High-resolution frequency-domain electromagnetic mapping for the hydrological modeling of an orange orchard

Response to Emmanuel Léger (RC1)

I carefully read the Manuscript entitled "High-resolution near-surface electromagnetic mapping for the hydrological modeling of an orange orchard", from Peruzzo et al.

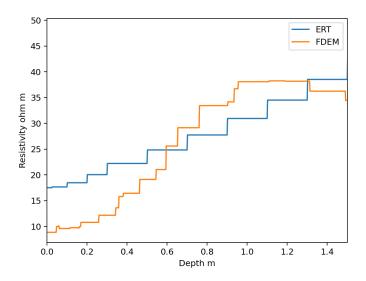
Line 448-449: ``These contrasting resisty values and their spatial distribution agree with ERT inverted in Figure 6.'' If you want to state that you probably need a bivariate plot, Em versus ERT and/or a deeper statistical analysis.

Done. We agree that the statement was overly generic, we rephrased it to clarify the aspects that are of interest and directly evident from the comparison of fig 6 and 7. We tried to plot the FDEM and ERT

resistivity profiles (at a plant position to capture the discussed RWU effect). In our opinion, it does not add much; the figure below shows 1) that the ranges agree and 2) that the profiles also agree. This is now more accurately stated, and visible from the two figures 6 and 7. The below figure also shows a combination of the expected water vertical redistribution (as the FDEM survey was performed after the ERT surveys, as described) and larger smoothing of the FDEM profile, related to the lower vertical resolution relative to the ERT with 20-cm spacing, which is expected and motivated the ERT. These two aspects were also included.

The sentence now reads as follows (L459)

The FDEM resistivity trend from the shallow irrigated layer ( $\sim$ 15  $\Omega$  m) to the deeper and drier RWU regions not yet reached by the water infiltration ( $\sim$ 45  $\Omega$  m) agrees with the ERT inverted section shown in Figure 6. Small ERT vs. FDEM differences are observed and expected due to the vertical water redistribution between the ERT measurements and successive high-resolution FDEM surveys, but also because of the higher resolution of the ERT surveys with 20-cm spacing relative to the FDEM, and consequent different model discretization and inversion smoothing.
